Scheme CORNER GYM
4/21/16

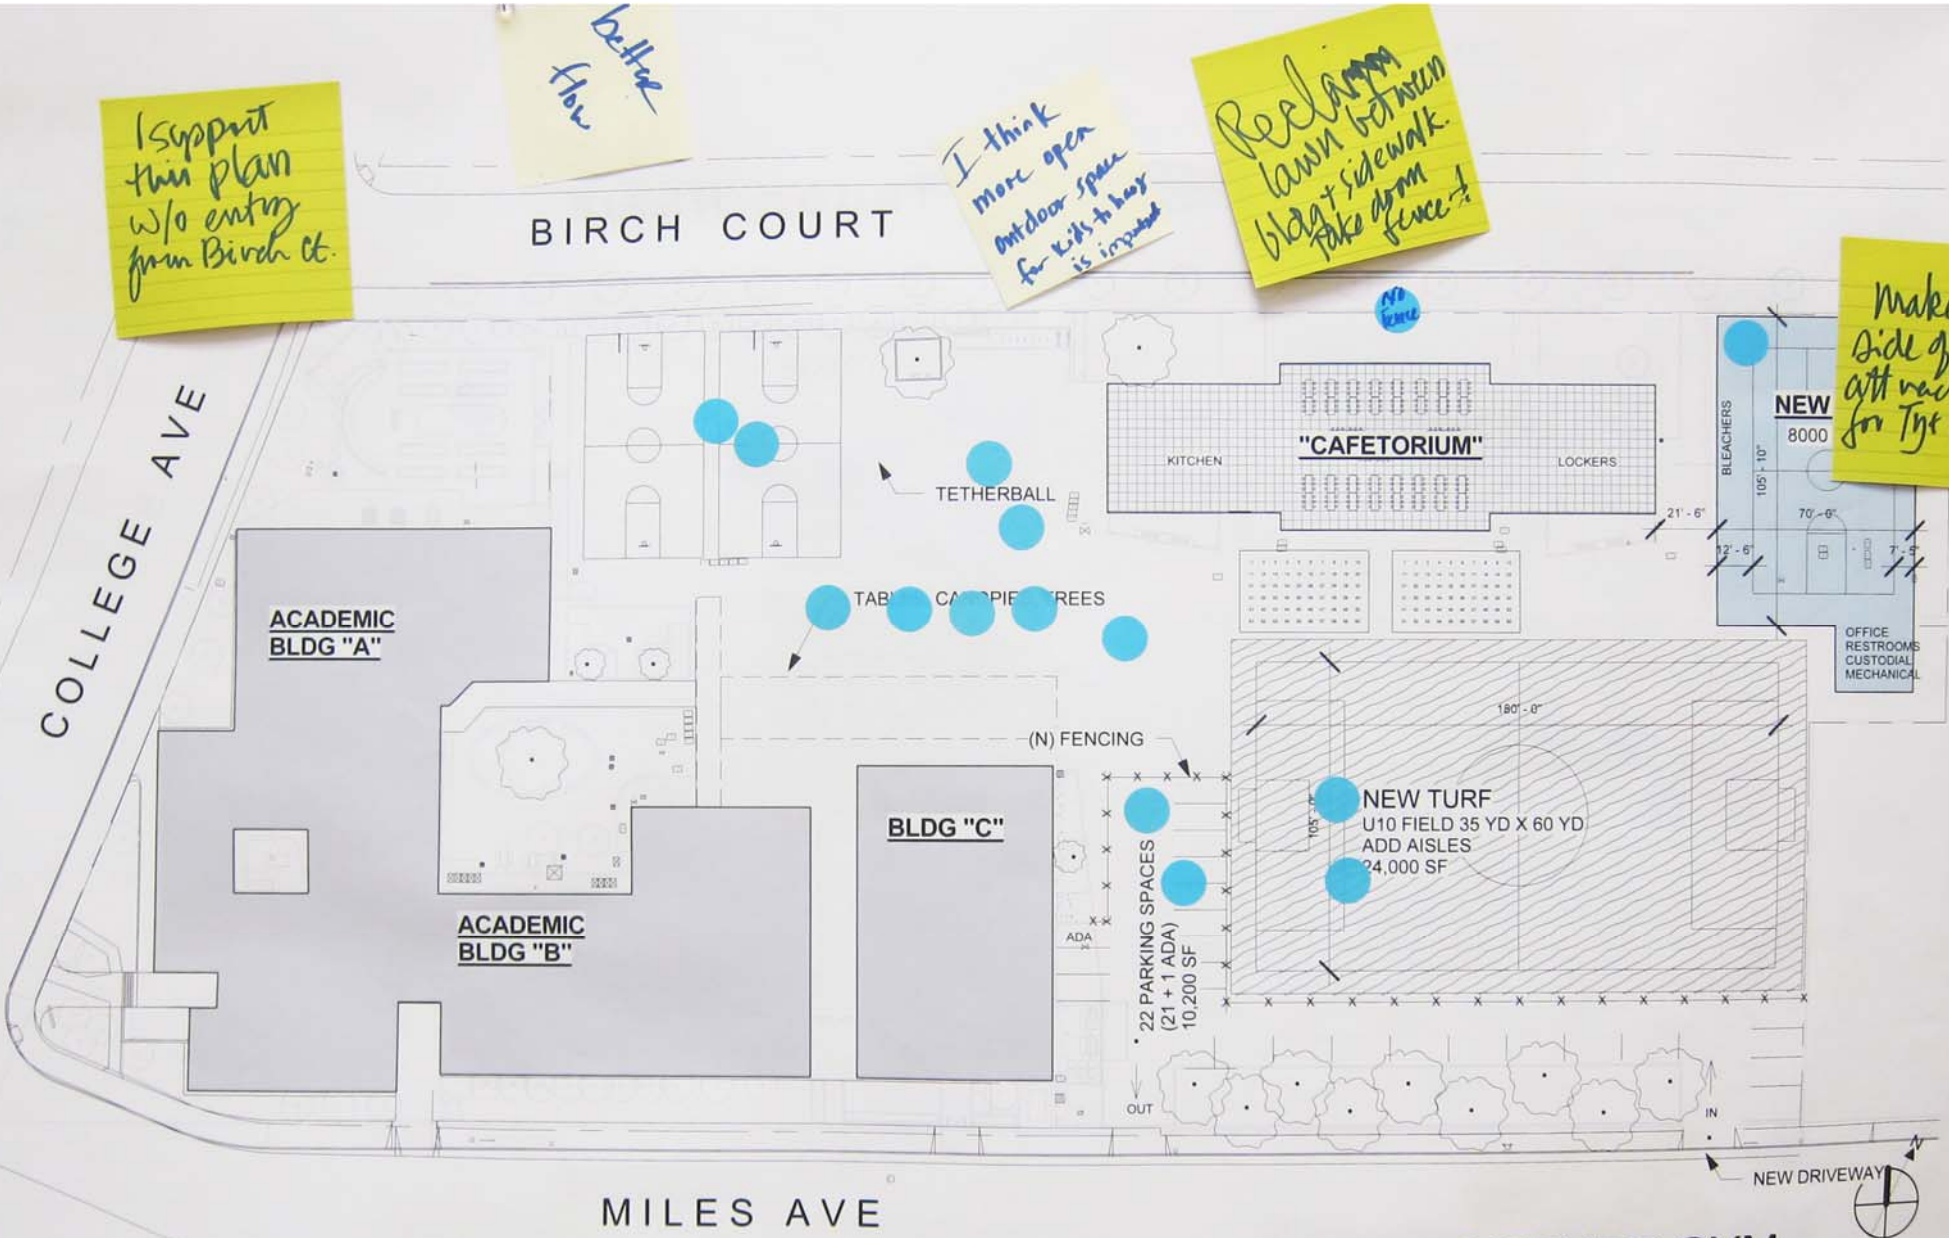
I support this plan w/o entry from Birch Ct.

better flow

I think more open outdoor space for kids to hang is important

Reel lawn between bldg + sidewalk take down fence!

Make this side of bldg att. to active for the lawn
